**RESPONSE TO MAY 31, 2019 USEPA CORRESPONDENCE
FORMER ROWE INDUSTRIES SUPERFUND SITE, SAG HARBOR, NEW YORK
NYSDEC SITE ID: 152106**

**WORK PLAN FOR *IN-SITU*
GROUNDWATER REMEDIATION**

**FORMER DRUM STORAGE AREA
FORMER ROWE INDUSTRIES SITE
SAG HARBOR, NEW YORK**

FIGURE
2

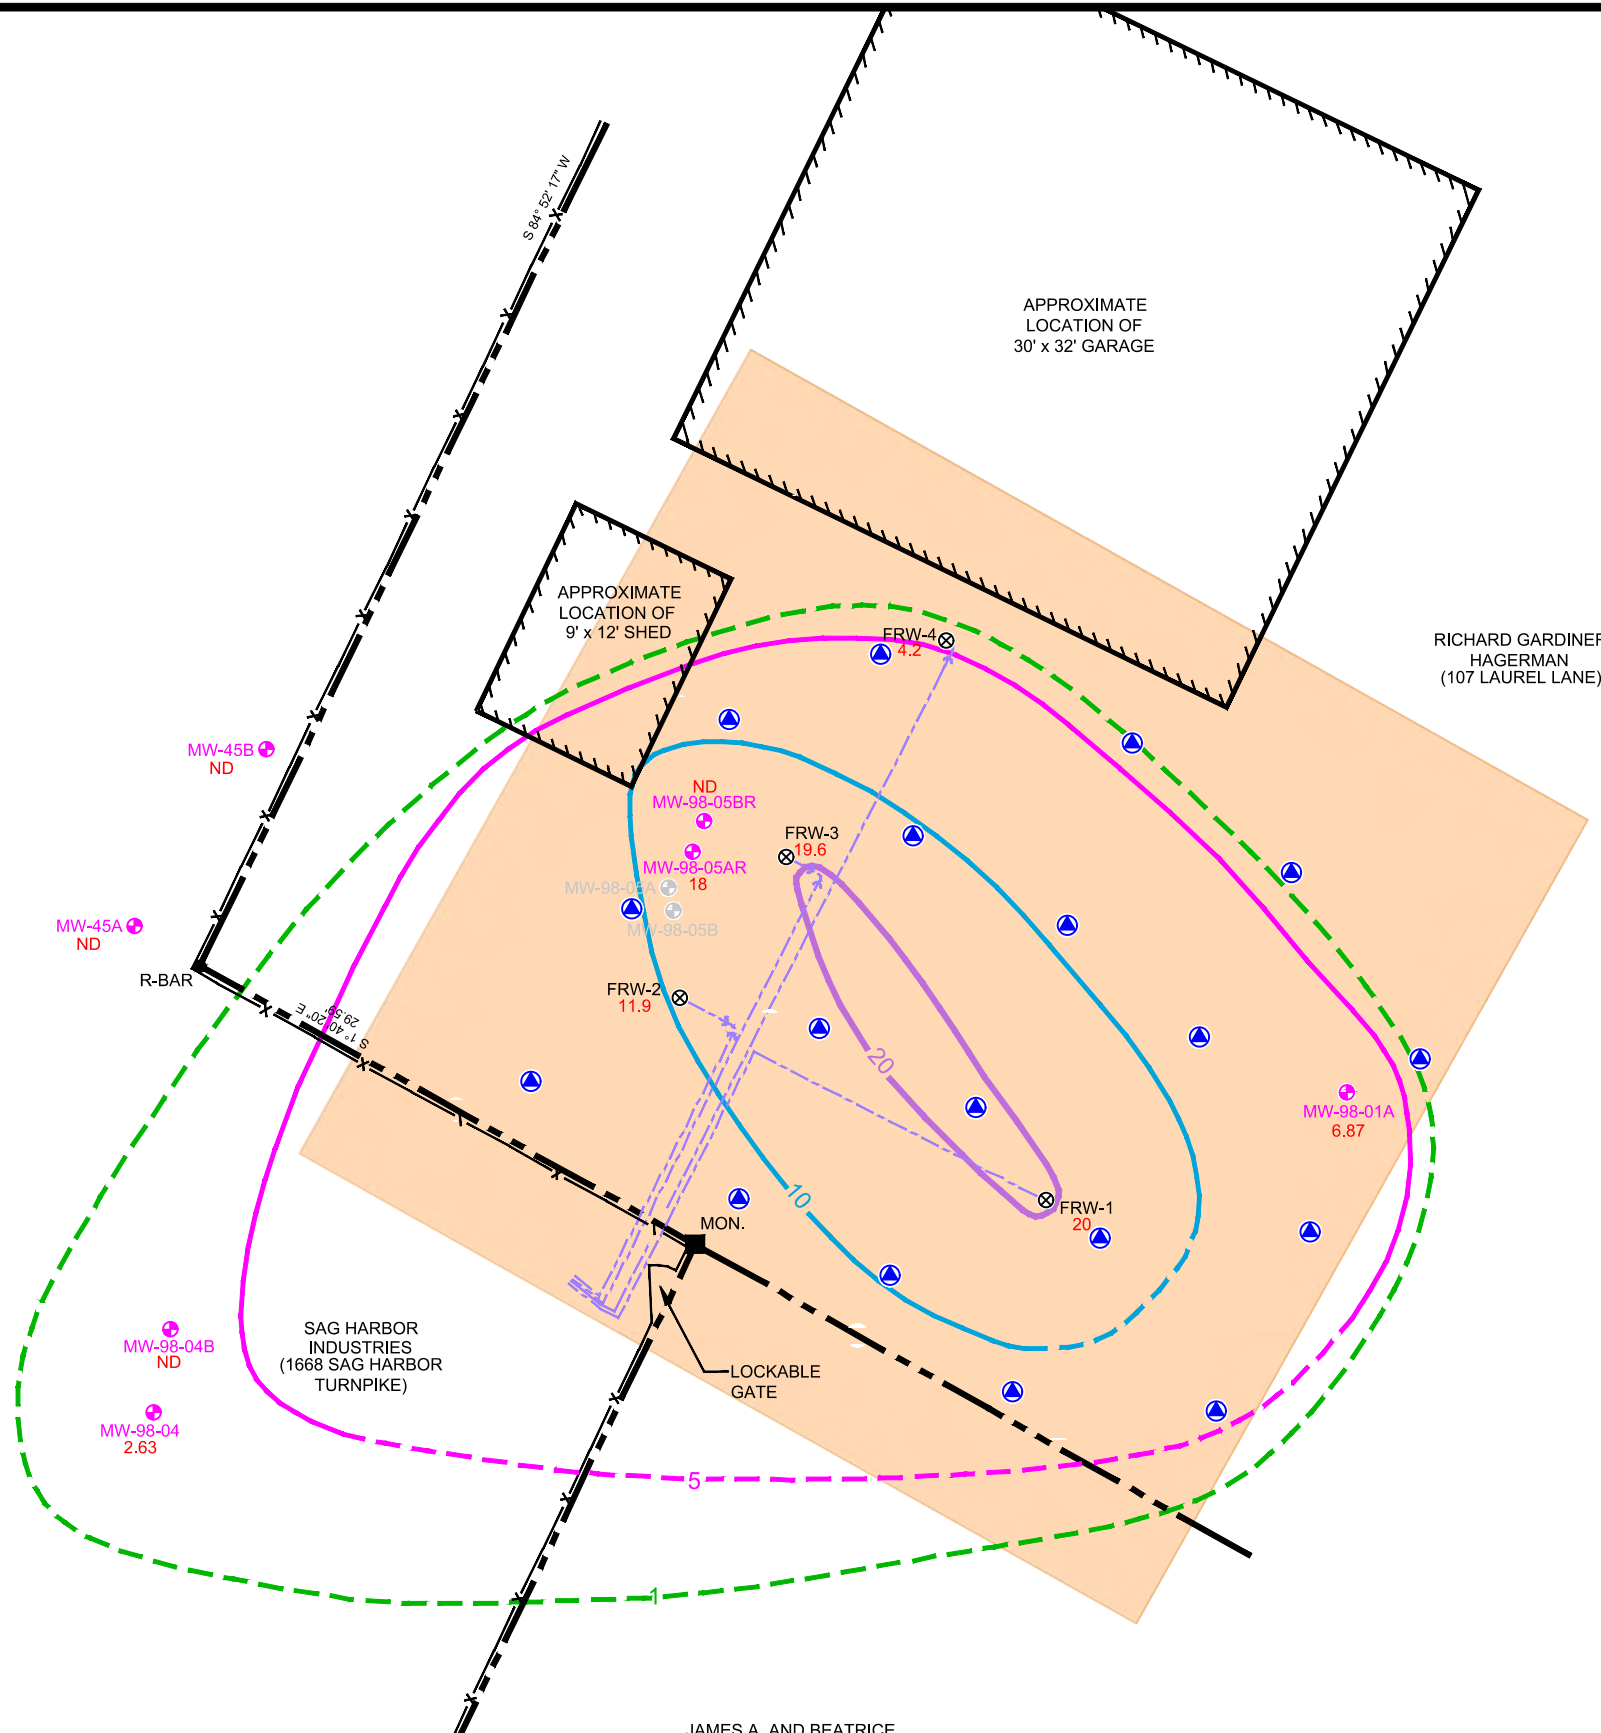
4. *What criteria was used to justify the target areas?*

The criteria used to justify the target groundwater treatment area is provided in Section 3.1 of the *Work Plan for In-Situ Groundwater Remediation*.

FIGURE
6

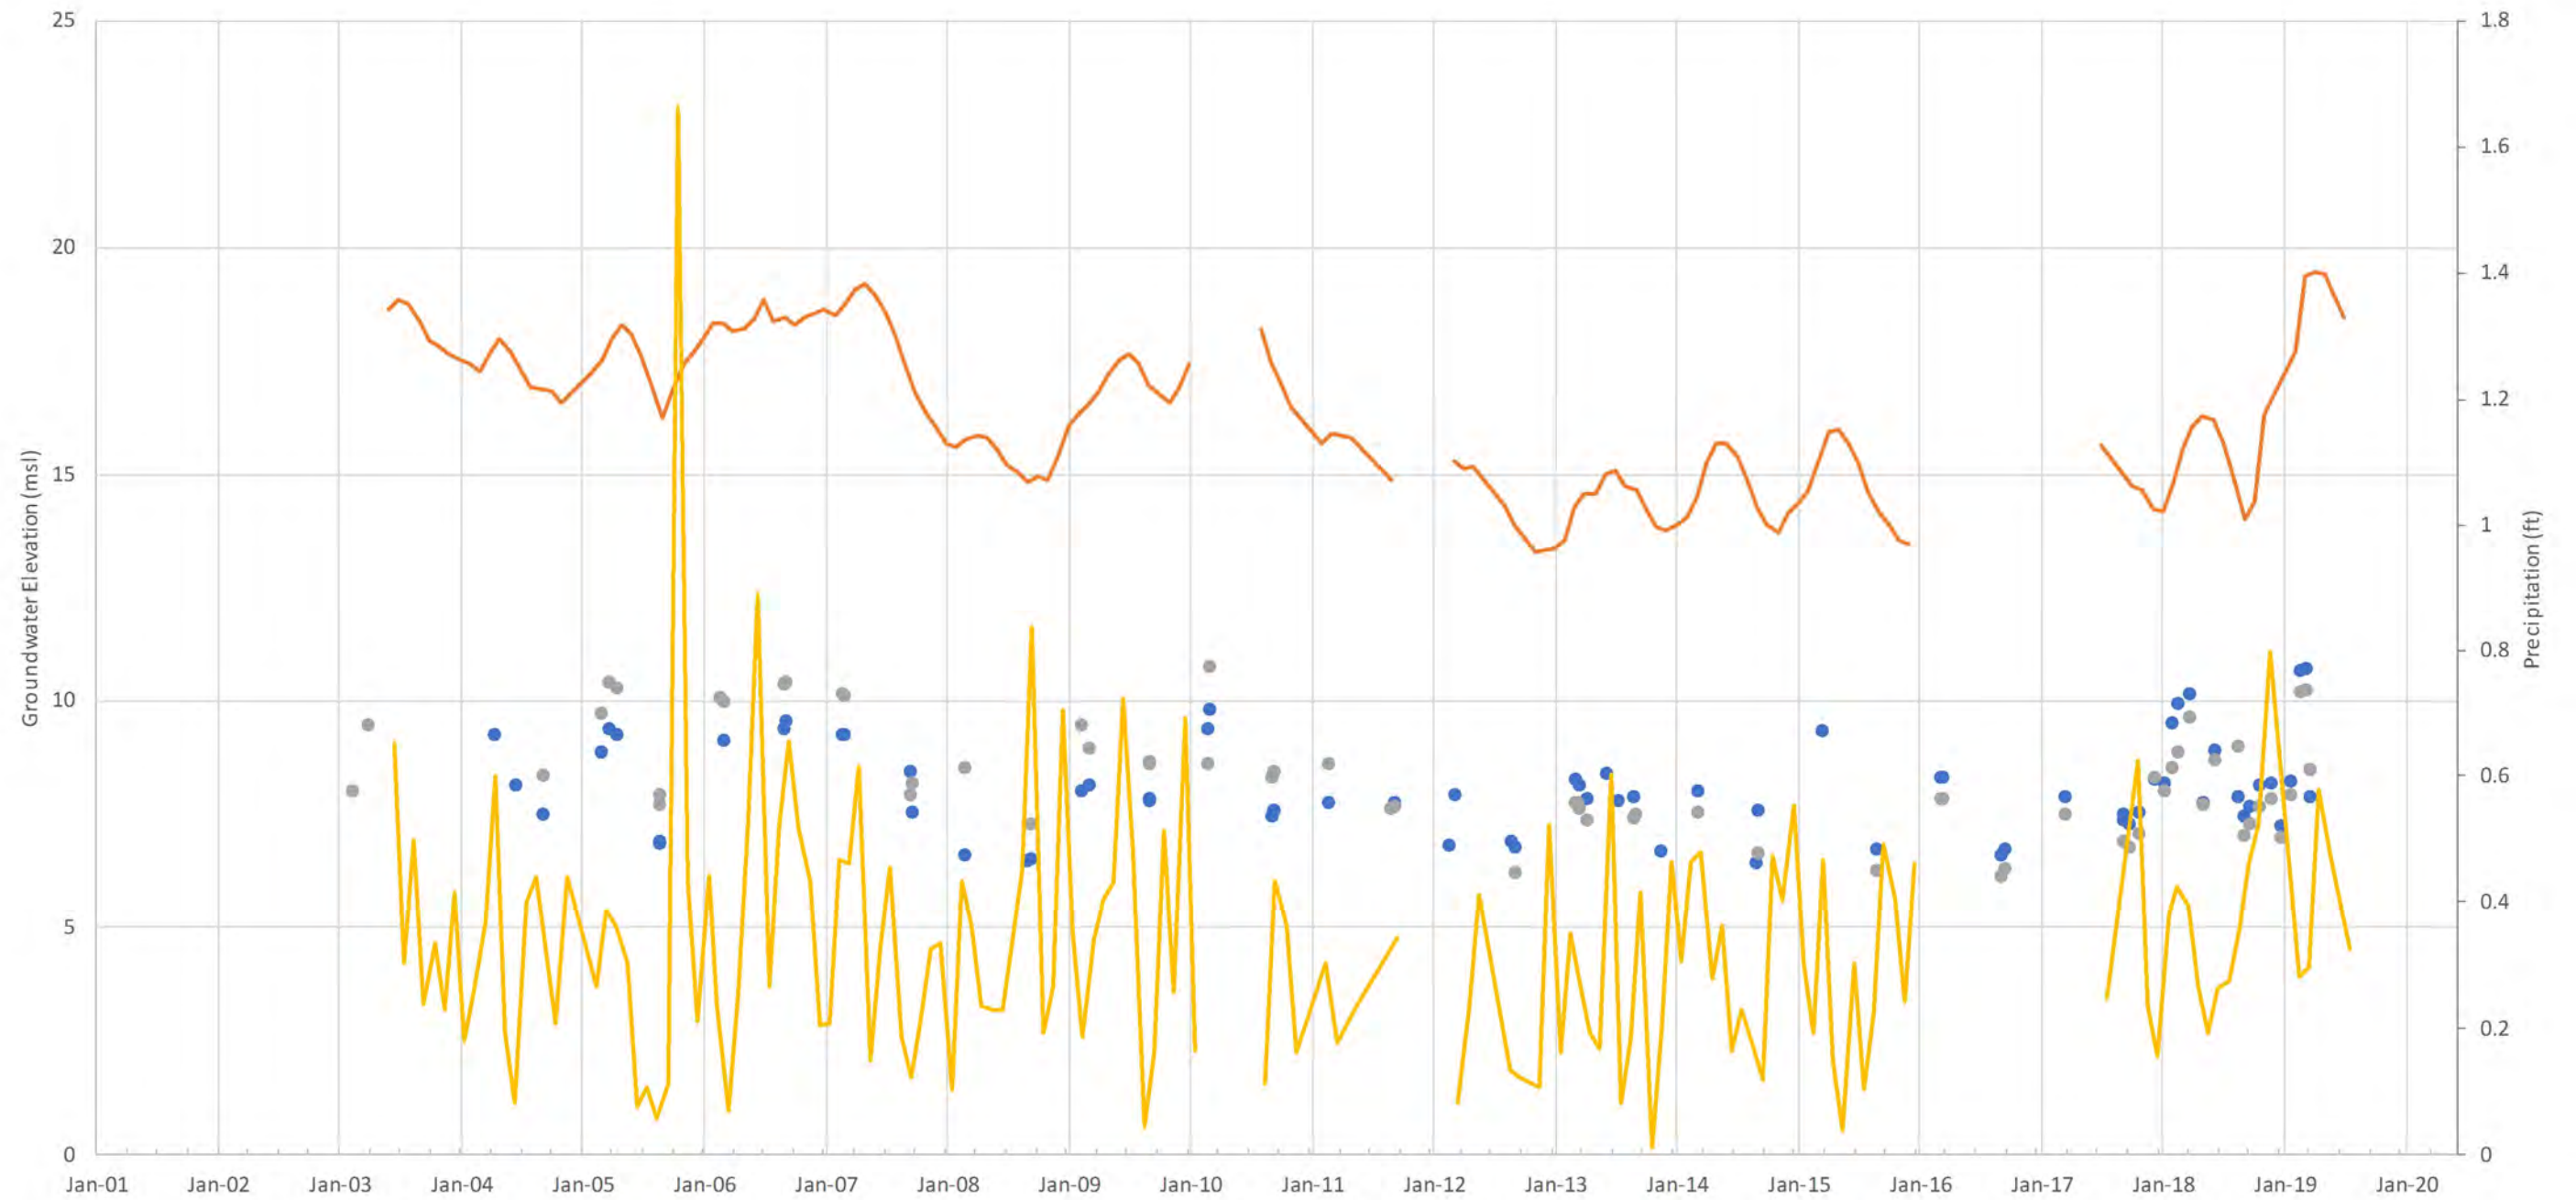
1. *Please include a hydrograph i.e., water levels over time at selected wells.*

Figure 6 of the *Work Plan for In-Situ Groundwater Remediation* provides water table elevation data for select wells plotted against local precipitation data from 2003 to present, and a discussion of these data is provided in Section 3.2 of the *Work Plan for In-Situ Groundwater Remediation*.
